Access Compliance Report

Public Rights-of-Way

(Curb Ramps)

Intersection ID: 46529	Main Street: BEAVER_CREEK_DR	Cross Street: PROSPERITY_CHURCH_RD	Location: NE
ADA ID: 686DAE119180	Ramp Type: Perp	Initial Pass/Fail: Fail	Overall Compliance: No
Severity Score: 8.75			
Codes/Mitigation Info/Possible Solution		Field Measurements/Component Compliance

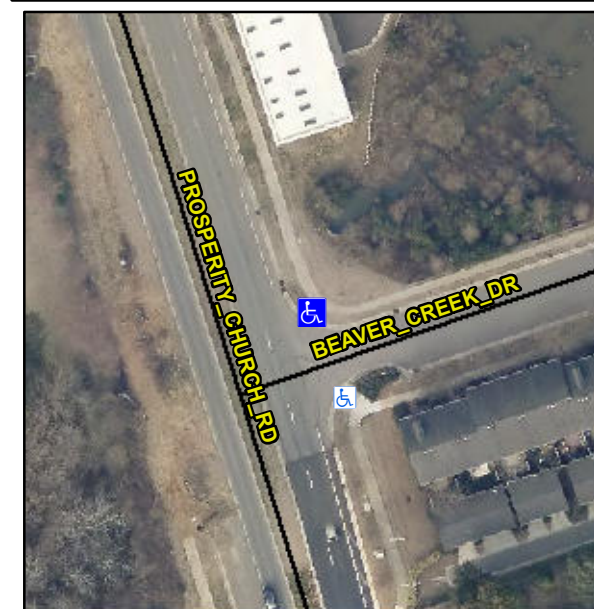
R304.5.1

Compliance	Description	Data	Compliance	Description	Data
N/A	Ramp Length (in)	72.0	Yes	Ramp Slope (%)	7.2
No	Ramp Width (in)	40.0	Yes	Ramp XSlope (%)	1.2
N/A	Flare Type LT	N/A	N/A	Flare Type RT	N/A
N/A	Flare Slope LT (%)	N/A	N/A	Flare Slope RT (%)	N/A
N/A	Flare Traversable LT?	N/A	N/A	Flare Traversable RT?	N/A
N/A	Landing Length (in)	N/A	N/A	DWS Provided?	N/A
N/A	Landing Width (in)	N/A	N/A	DWS Contrast?	N/A
N/A	Landing Slope (%)	N/A	N/A	DWS Length (in)	N/A
N/A	Landing X Slope (%)	N/A	N/A	DWS Full Width?	N/A
N/A	Landing Curb? (Y/N)	N/A	N/A	DWS Offset (in)	N/A
N/A	Shared Landing?	N/A			
N/A	Gutter Ponding?	N/A	N/A	Gutter Slope (%)	N/A
N/A	Gutter Lip Ht (in)	N/A	N/A	Gutter X Slope (%)	N/A
N/A	Painted X Walk1?	No	N/A	Painted X Walk2?	N/A
	X Walk 1 Direction	To S		X Walk 2 Direction	N/A
N/A	X Walk 1 Width (in)	N/A	N/A	X Walk 2 Width (in)	N/A
	X Walk 1 Slope (%)	2.4		X Walk 2 Slope (%)	N/A
	X Walk 1 X Slope (%)	0.9		X Walk 2 X Slope (%)	N/A

Remove & Replace Entire Ramp.
